Cold Engine Tick Noise (Replace Pistons) #01-06-01-005

2000-2001 Buick Century

with 3.1L Engine (VIN J - RPO LG8)

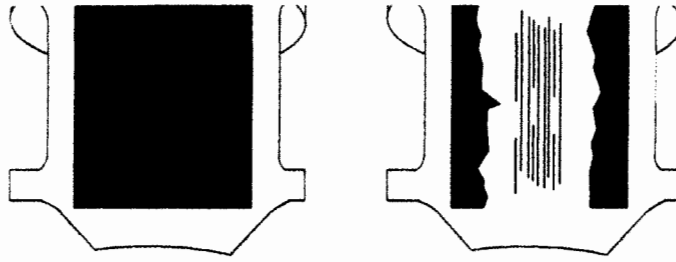
The noise may be caused by excessive piston to bore clearance during cold engine operation resulting from the specific piston design used in cylinders 1 through 4.

Service pistons for cylinders 1 through 4 will now be of the same design of those used for all production 2000 and 2001 for cylinders 5 and 6, and will have polymer coated piston skirts. Pistons in cylinders 5 and 6 are not exhibiting the prescribed noise condition.

FIGURE Cylinder Wall Finish(c)

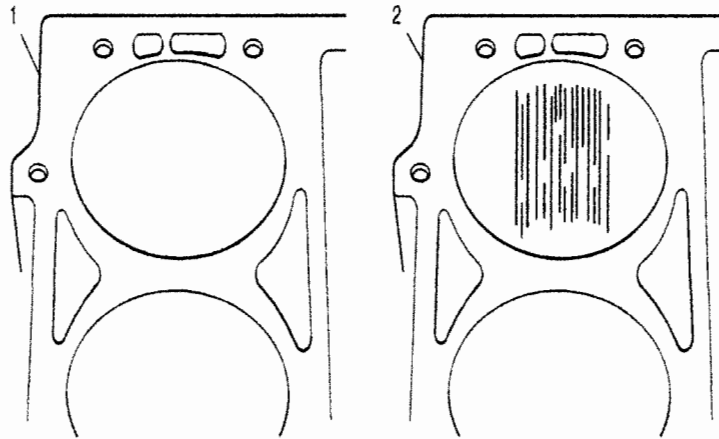
Removal of pistons from engine cylinders 5 and 6 is NOT necessary if equipped with polymer coated pistons. It is recommended to rotate the crankshaft until the piston skirt is exposed in the lower crankcase area for inspection. Replace pistons in engine cylinder positions 5 and 6 ONLY if there is evidence of damage to the polymer coating on the piston skirt, or cylinder wall wall (heavy scratches) is evident.
